Vieux Carré Commission Meeting

Wednesday, February 19, 2026

718 Bourbon – VCC Review and Response

1 A101 FIRST FLOOR PLAN 1/4" = 1'-0"

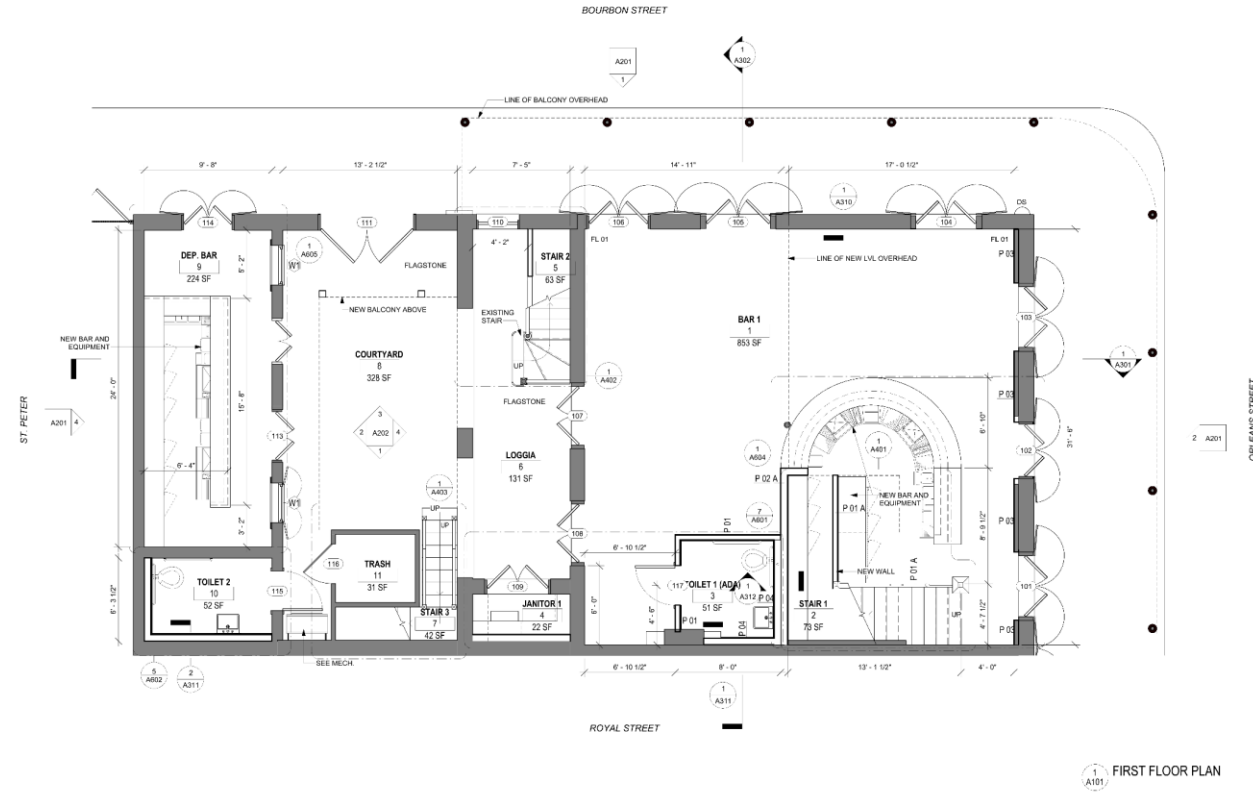
- *Demolish two small doors on first floor of dependency.* The two small doors will be replaced with one single door accessing a bathroom. This portion of the dependency was a two-story addition that appears between the 1908 and 1940 Sanborn maps. Staff has no objection.

- *Demolish and rebuild courtyard platform spanning between main building and dependency and install two large condensers.* The platform is shown to extend over the dependency balcony, resulting in a step up from the balcony to the platform, which is noted as plywood, not decking. **A202 notes that it is decking.** It appears from elevations that the equipment may be visible from the street. The equipment will block operation of a pair of dependency shutters. **This equipment has been relocated to the first floor.** It appears that the units are not serviceable without removal of the platform railing. **Engineer confirms the units will be serviceable as-built.** The electrical drawings show the disconnects mounted to the inside face of the courtyard wall. **Relocated to the new railing.**

- *Install wall-mounted mini split(s).* Discrepancies in the drawings show a mini split mounted to the first-floor courtyard wall, as well as one on second floor dependency wall. The second-floor location is not shown in elevation, but conflicts with shutters emergency lighting. Staff requests clarification on the number and locations proposed. The first-floor location is not objectionable, but the second-floor location is. **DSC-1 will be mounted on the first floor behind the Toilet 2 door.**

BOURBON ST ELEVATION
1/4" = 1'-0"

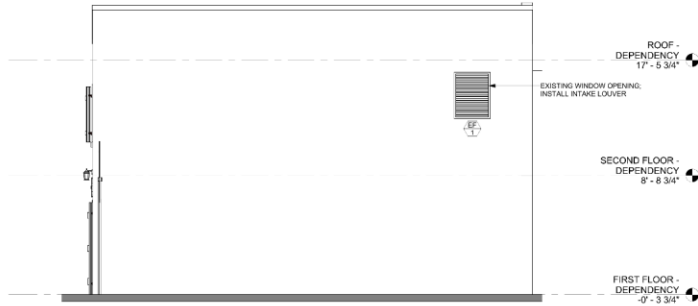
- Remove inappropriate gallery rail extension, install new 42” guardrail behind. The new guardrail is shown attached with iron base plate, not touching the historic rail. More information needs to be provided regarding the structural attachment and the placement of its verticals, particularly since the rail is continuous. **Verticals placed at 6’-0” O.C. Wood screws to fasten baseplate.**

SHEET NAME: COURTYARD ELEVATIONS & ENLARGED PLAN

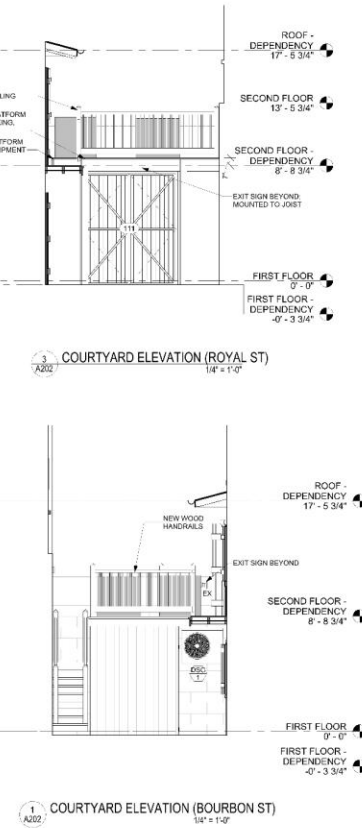
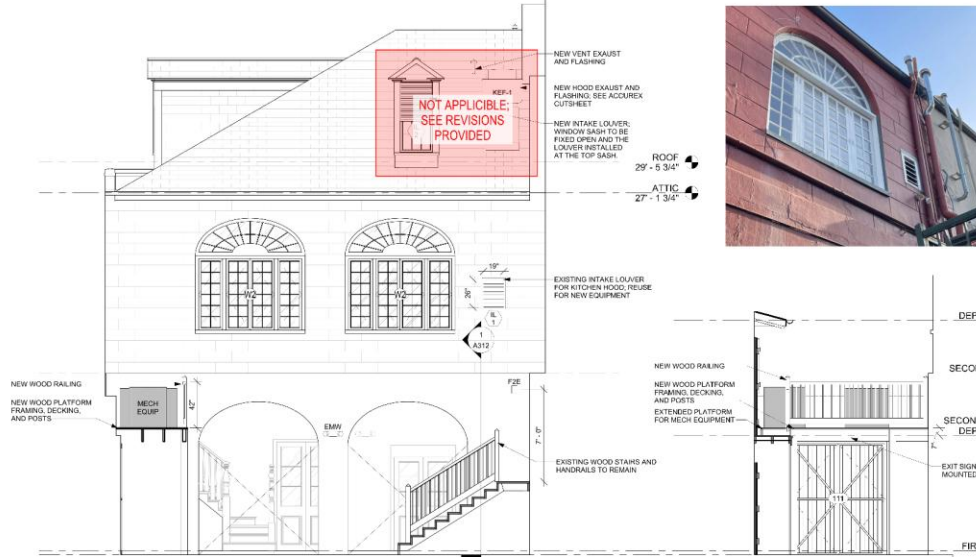
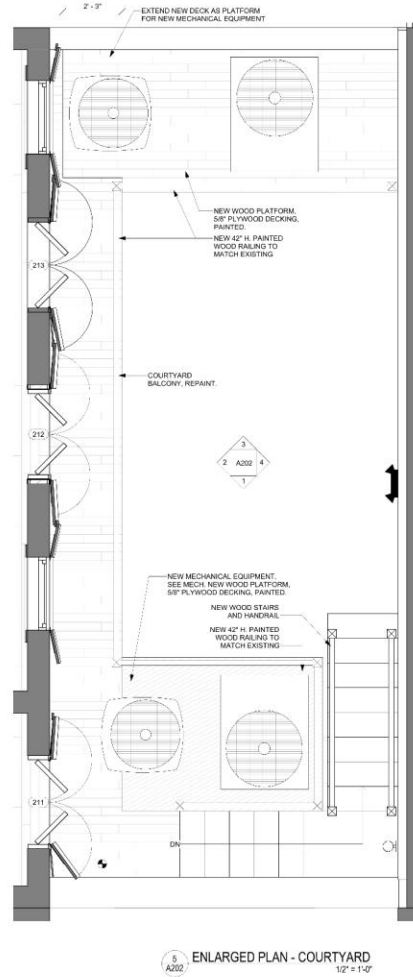
- An existing intake louver on the rear of the main building is labeled as being reused for other equipment. This vent is a work without permit violation but is discretely located. It appears to be drawn larger than it appears in photos; staff requests confirmation on the size from the applicant. **Size confirmed on A202, 26” x 19”.**

01 SECOND FLOOR PLAN
1/4" = 1'-0"

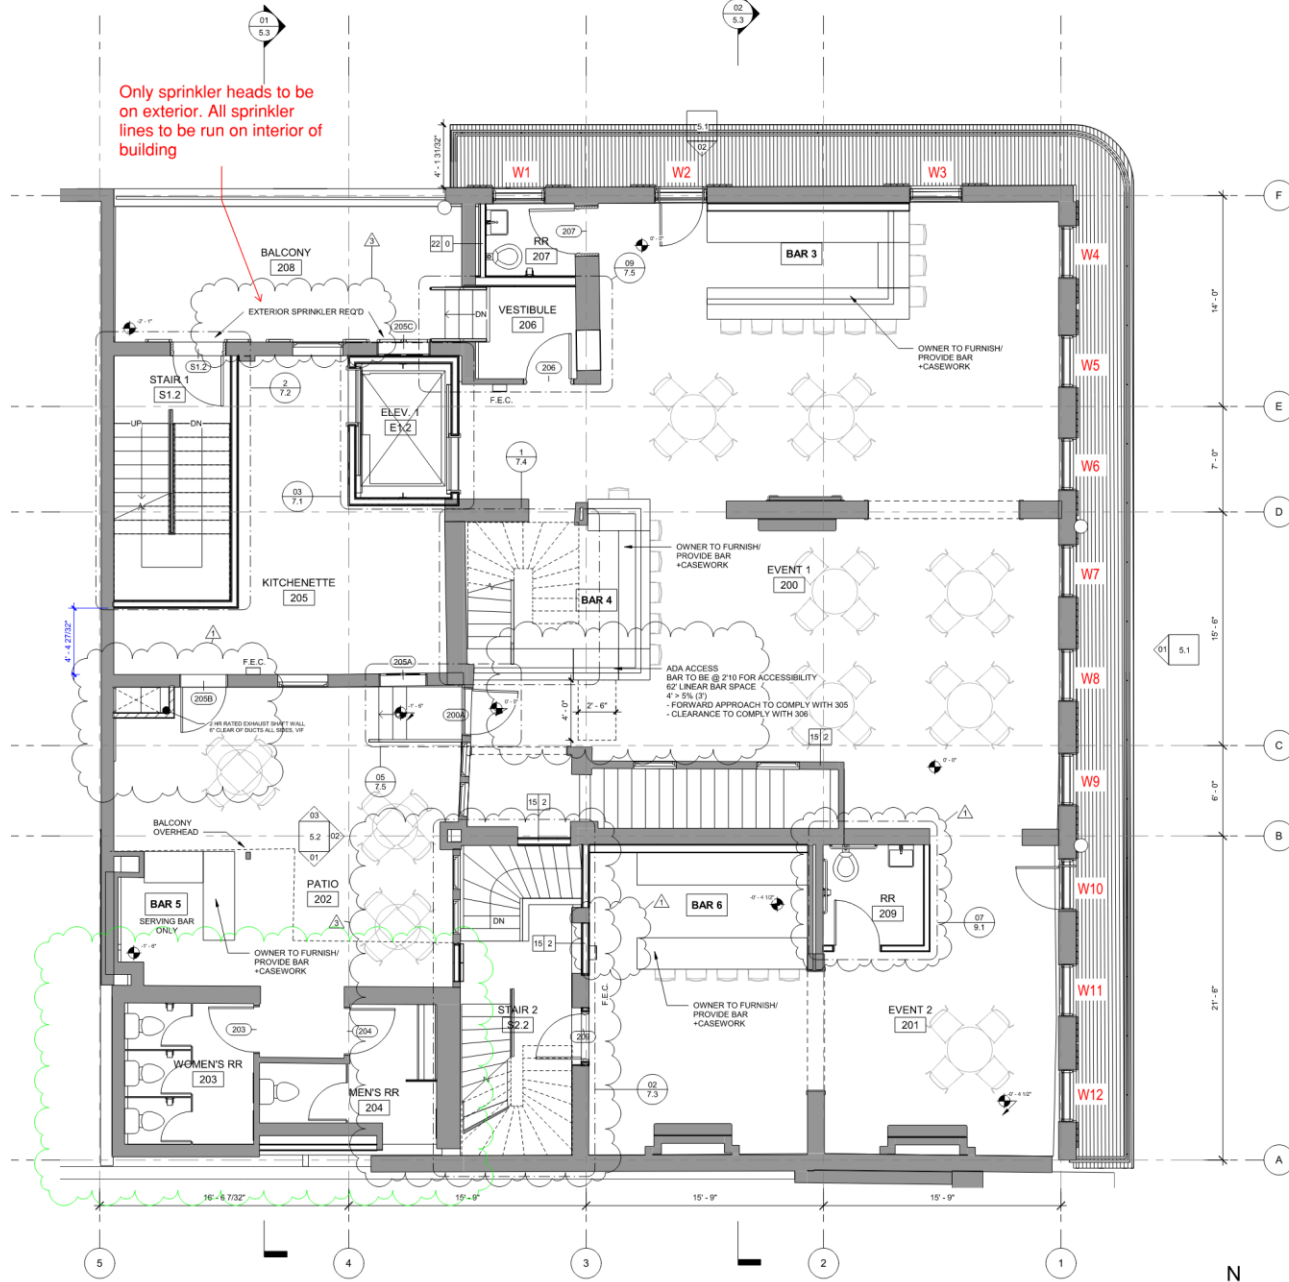
Only sprinkler heads to be on exterior. All sprinkler lines to be run on interior of building
